In the Matter of:)	Docket No. 08-IEP-1
)	
Preparation of the)	COMMENT ON DRAFT 2008 IEPR REPORT
2008 Integrated Energy Policy Report)	
(2008 IEPR))	
)	
_____)

Comments of the California Public Utilities Commission on the Draft 2008 IEPR Update Report

Figure 7
Number of Months Needed to Approve Applications Related to New Power Plants

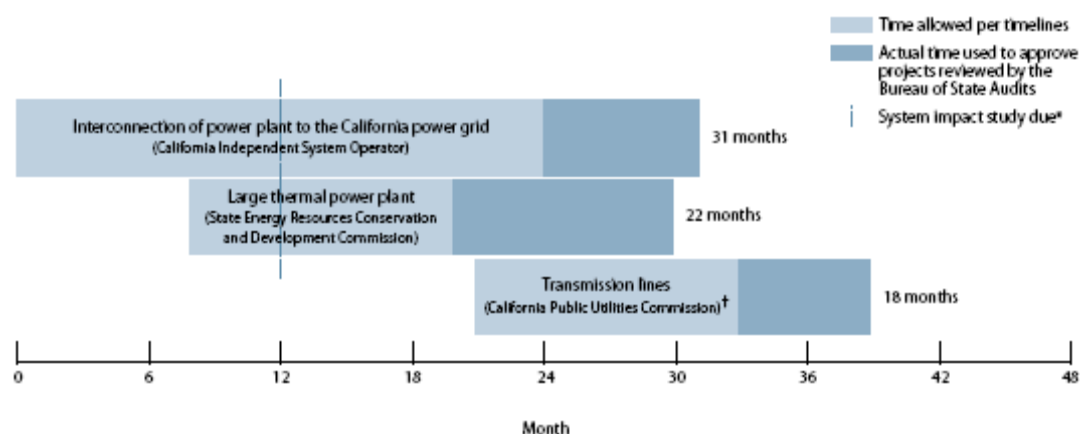
- Finally, we note that a recent study by the California State Auditor found that the CPUC transmission approval process takes less time, on average, than both the CAISO's interconnection process and the CEC's generation permitting process (see chart below).¹⁹
